TO: Members of the Plan Commission
FROM: Hickory Hurie
SUBJECT: Analysis of IZ Waiver Request for Capitol West (Alexander and Company)
DATE: June 15, 2005

Re: Capitol West – Block 51 SIP
Recommendation of Conditions of Approval for the Plan Commission

RE: Capitol West – Block 51 SIP Response to Neighborhood Comments

RE: Capitol West—Block 51 Amended GDP
Capitol West—Block 51 SIP
Requested Modification to Conditions of Approval

Drawing A: 2 votes

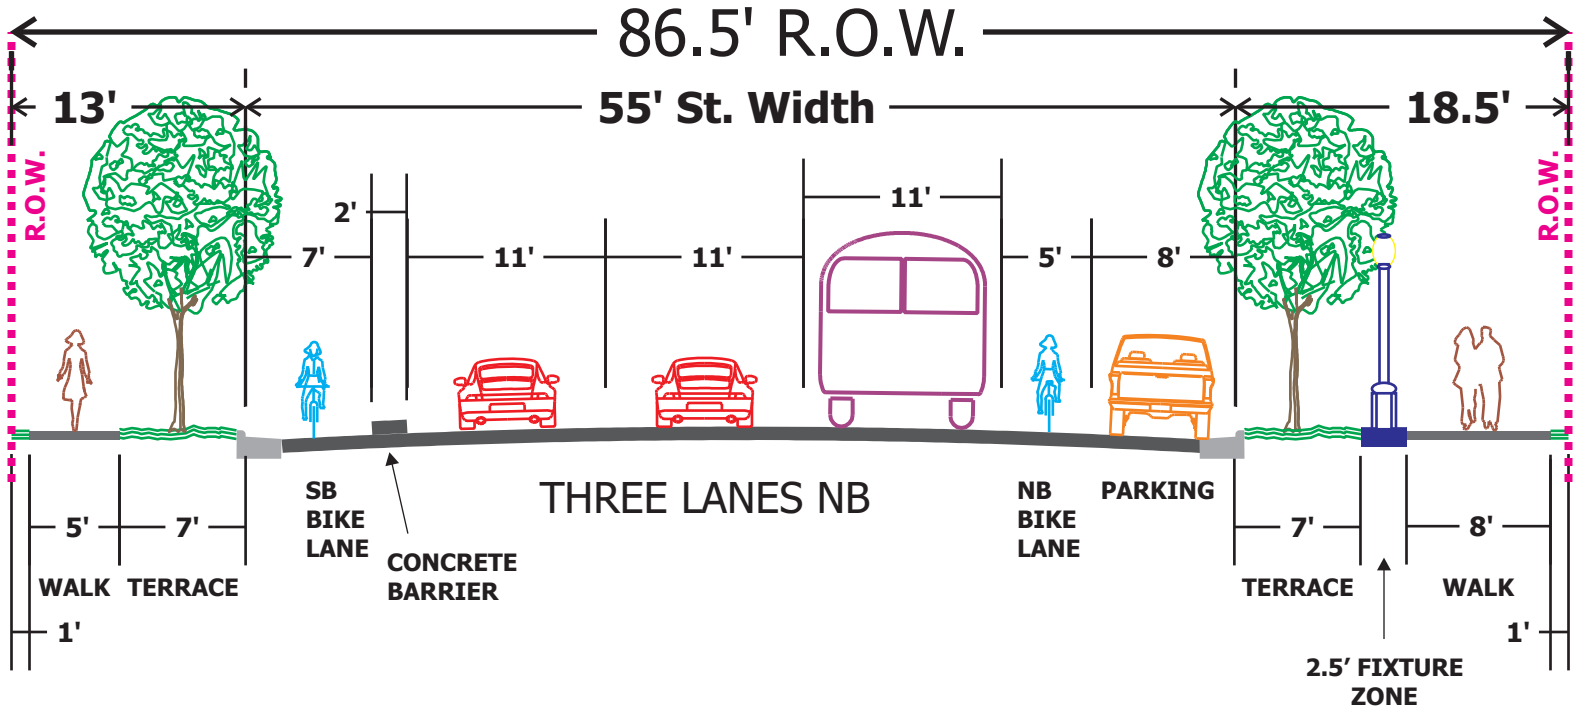
Suggestions and comments under categories of sidewalks, terraces, parking, bike lanes, traffic lanes and direction, street amenities, and setback were recorded (below). Residents divided into small groups each of which developed a proposed Broom Street cross sections. The four groups had ROWs ranging from 80 to 88 ft. Further discussion then arrived at a consensus for an 83 ft. minimum ROW (drawing C).

- Separate zone for street lighting desirable
- Specify a building setback
- Utilities will go underground if street is rebuilt
- Median (if 2-way) to calm traffic/provide pedestrian refuge
- Double tree terrace on east side
- Symmetry from one side of street to the other

Design B

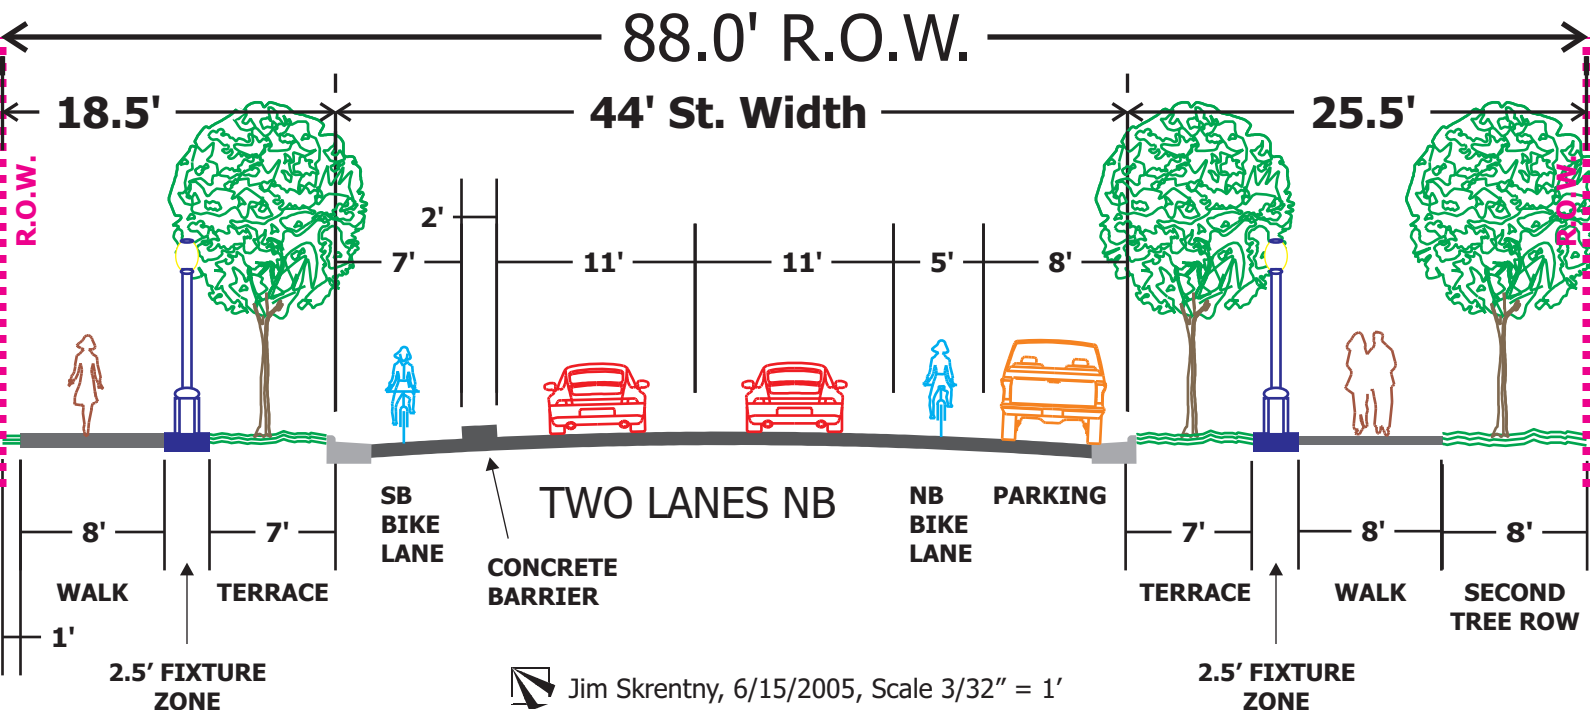
- Asymmetric Design: West Side (left) and East Side (right) both with Enhanced Pedestrian Walkways
- Two Northbound Traffic Lanes and Parking on East Side with Northbound and Southbound Bike Lanes
- Requires 22' Setback from Existing Property Line

Design C

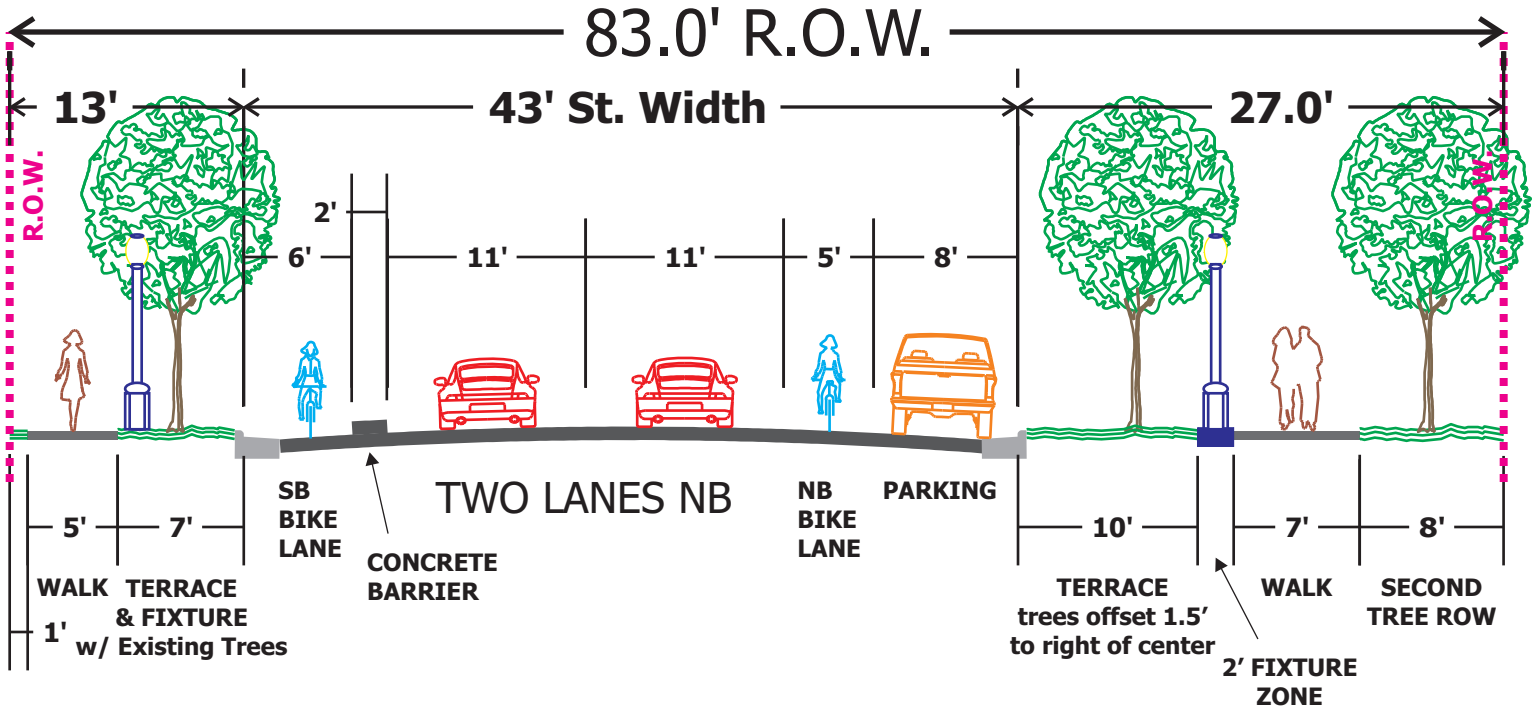
- Asymmetric Design: West Side (left) Fixture Added, East Side (right) Enhanced Pedestrian Walkway
- Two Northbound Traffic Lanes with Northbound and Southbound Bike Lanes
- Maintains Option for Future Mass Transit Lane (see below)
- Requires 17' Setback from Existing Property Line

Design C+

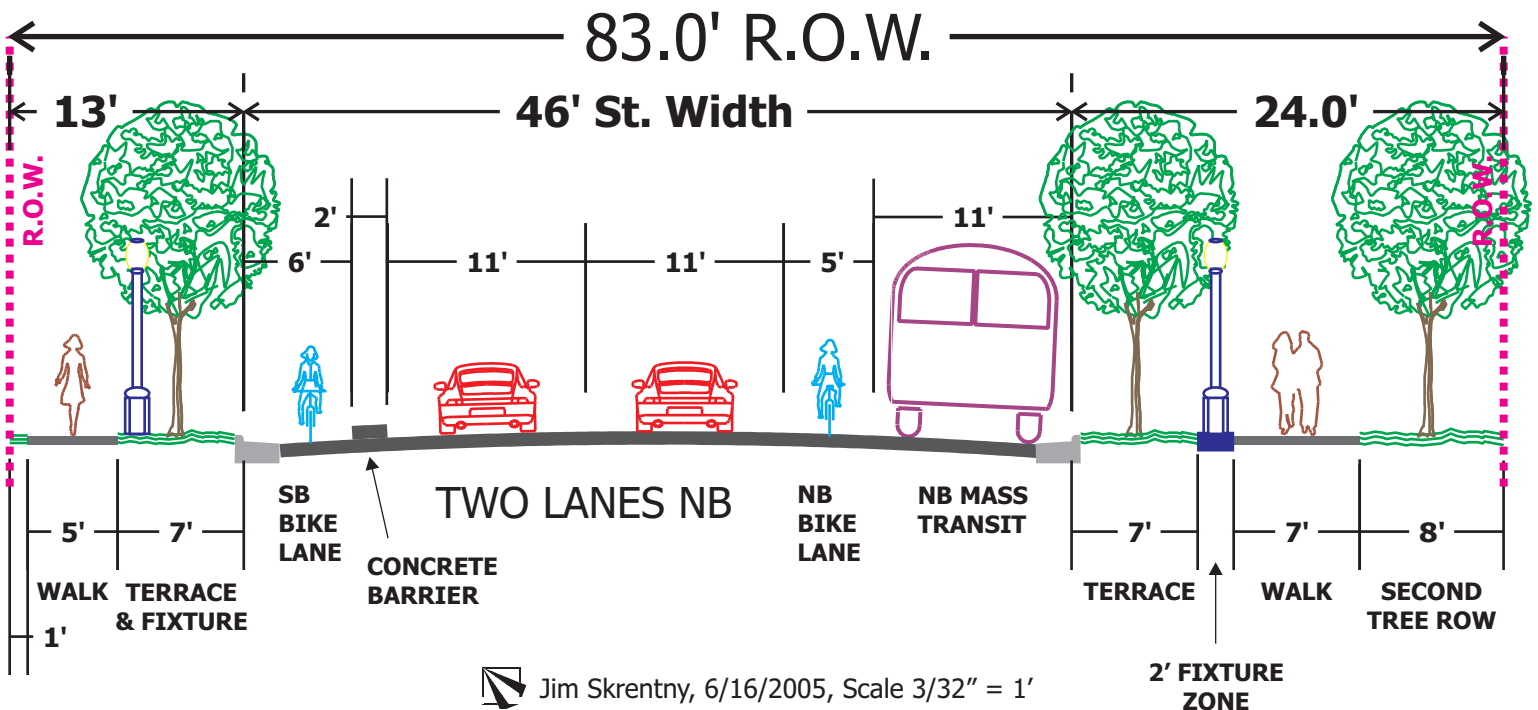
- Parking and 3' of East Terrace Replaced with Mass Transit Lane
- East Terrace Trees Spared Due to Planting Offset in Design C

Design D

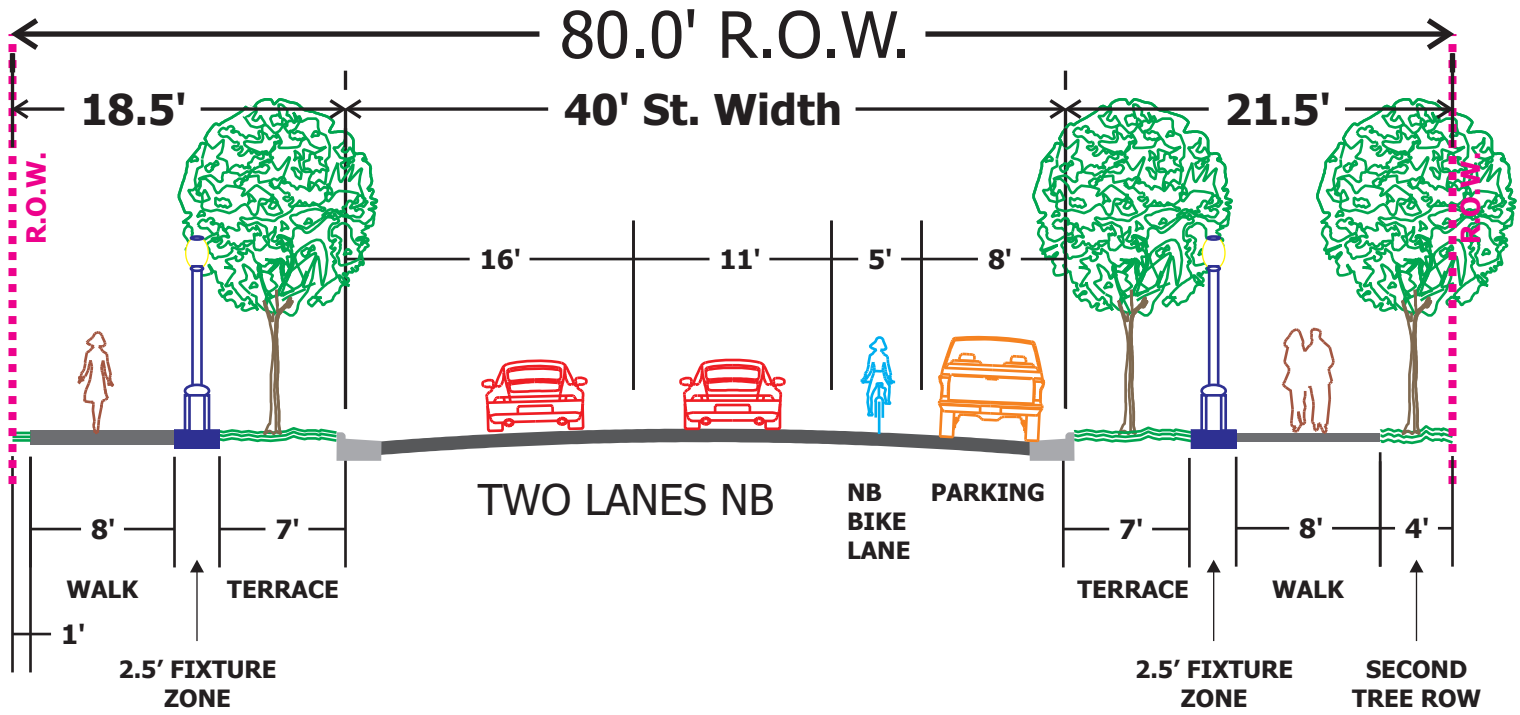
- Asymmetric Design: West Side (left) and East Side (right) both with Enhanced Pedestrian Walkways
- Two Northbound Traffic Lanes and Parking on East Side with Northbound Bike Lanes
- Requires 14' Setback from Existing Property Line
